City of Portland, Oregon
Bureau of Development Services
Land Use Services

NOTICE OF A TYPE II_x DECISION ON A PROPOSAL IN YOUR NEIGHBORHOOD

CASE FILE NUMBER: LU 13-191304 LDP

Site Address: 4260 SW Carson Street

CASE NO. *2213-191304*
 EXHIBIT *C.2* *LOP*

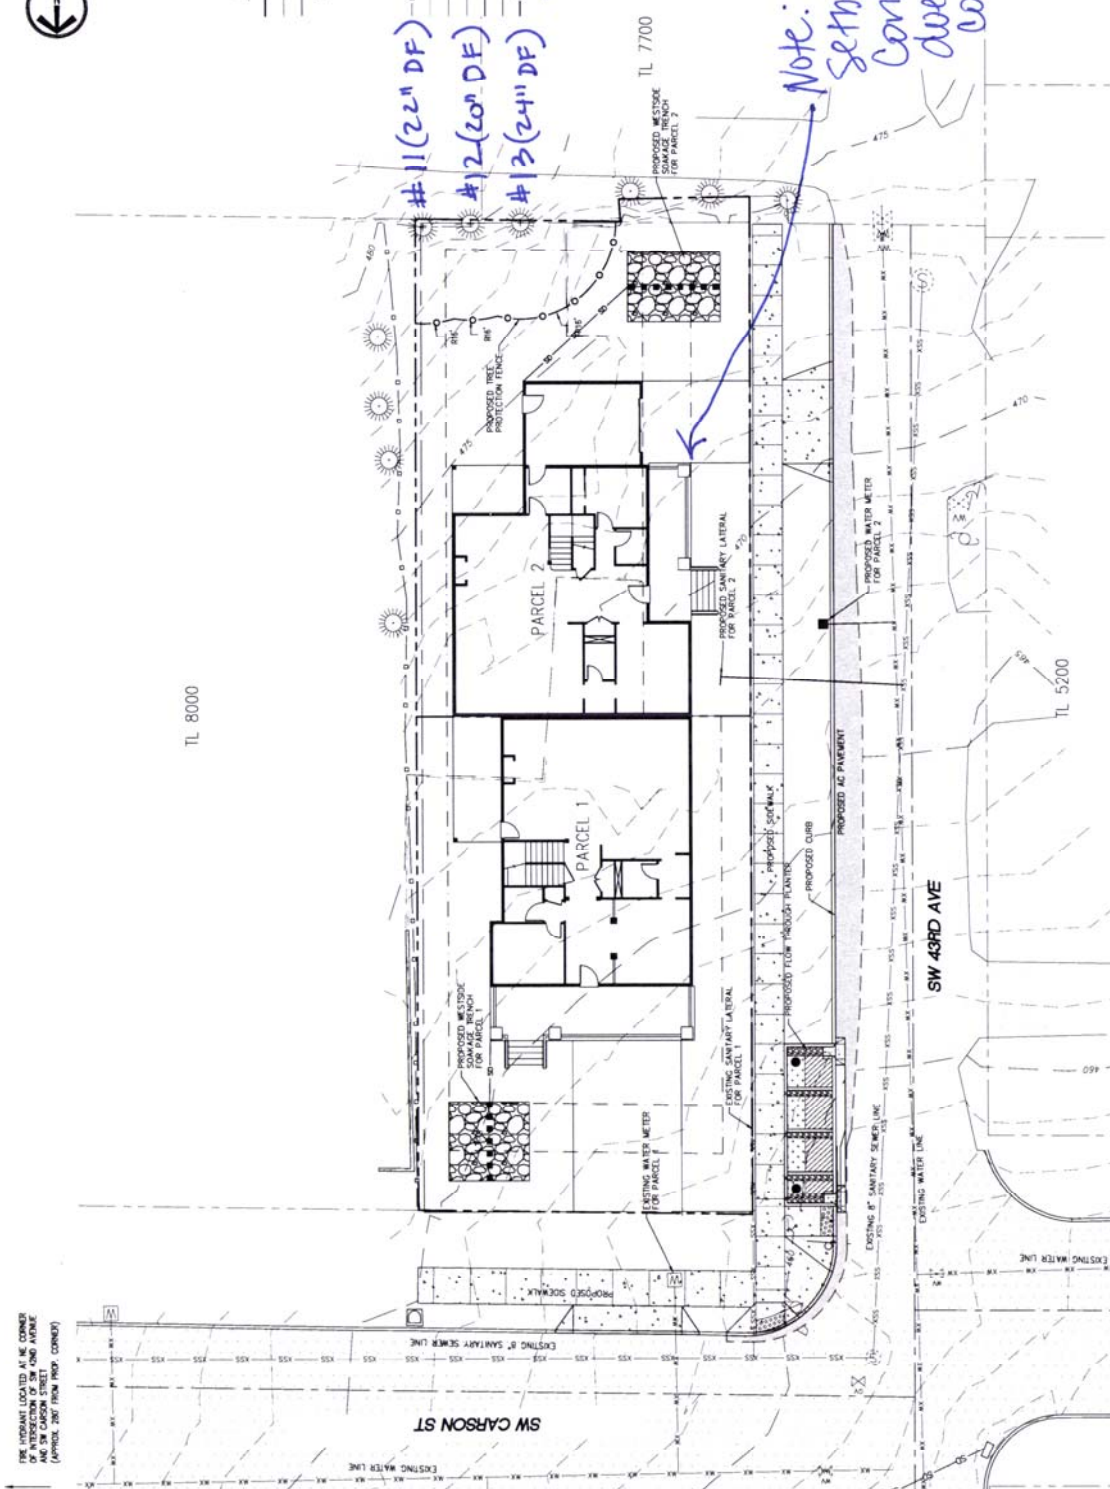
7. Trim must be the same in type, size and location.
 8. Windows must match in proportion and orientation.
- Building Setbacks – The land division site is within the R7 zone, which has a minimum 15' front setback and 5' side and rear setbacks. Because Parcels 1 and 2 will be separate lots, the required front setback will need to be met on each lot. The applicant has been notified that their conceptual development plans do not comply with this setback on Parcel 2.

Note: Min. Front Setback = 15' Conceptual Plan does not comply.

2. The applicant shall provide an updated conceptual development plan that shows footprints for the attached houses that meet setbacks for the R7 zone, driveways, tree preservation and appropriately sized stormwater facilities for review and approval by the Bureau of Environmental Services.
3. The applicant shall meet the requirements of the Fire Bureau for ensuring adequate hydrant flow from the nearest hydrant. The applicant must provide verification to the Fire Bureau that Appendix B of the Fire Code is met, the exception is used, or provide an approved Fire Code Appeal prior final plat approval.
